UNITED STATES PATENT AND TRADEMARK OFFICE

James Richard John Duke

Office Action Summary	Application No. 10/576,744	Applicant(s) DUKE, JAMES RICHARD JOHN	
	Examiner DANIELLE CLERKLEY	Art Unit 3643

FIG. 2

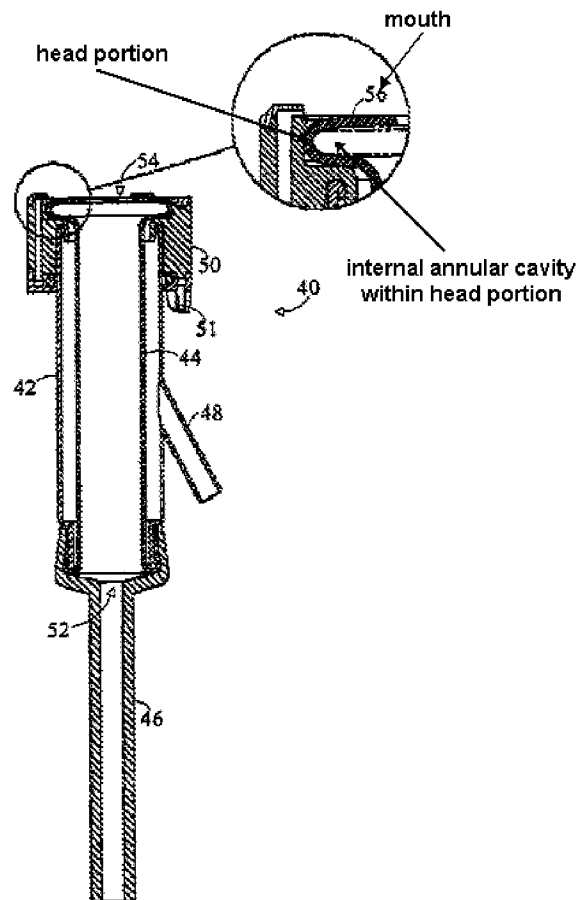
17. In re claims 39 and 42, Wipperfurth et al. shows milking equipment comprising: at least one milking cluster (Fig. 1) including a plurality of teat cups (13); each of said teat cups comprising a flexible liner (Fig. 2: 44) for engaging about a teat of an animal to be milked, said liner having a head portion at one end provided with a mouth (56) through which said teat is engageable with said flexible liner, an internal annular cavity (see diagrammed Fig. 2 below) and a milk discharge passageway (at bottom opening 52 of

the teat cup) at the opposite end thereof; post-milking flushing means (50) for discharging treatment fluid upon termination of a milking stage (Col. 6, lines 27-36); said post-milking flushing means comprising at least one nozzle (60, 62, 64); a plurality of short milk tubes (14) respectively connecting said discharge passageways of said teat cups to a clawpiece (10) which collects milk discharged from said teat cups for onward delivery; and control means (120, 170) for initiating supply of treatment fluid to said at least one nozzle of each of said teat cups upon take-off so that withdrawal of said teat cups wipes said treatment fluid down said teats (as discussed Col. 8, lines 57-61).

18. Wipperfurth et al. shows said post-milking flushing means comprising at least one nozzle (60, 62, 64) for discharging treatment fluid, but fails to show the post-milking flushing means is arranged to discharge treatment fluid in a direction towards said discharge passageway of the flexible liner. However, Guo teaches milking equipment (Fig. 6) comprising a teat cup (14) comprising a flushing means (30, 76) having at least one nozzle (26) arranged to discharge treatment fluid in a direction (as discussed in [0025] and indicated by arrows showing treatment fluid flow through means 30 and into
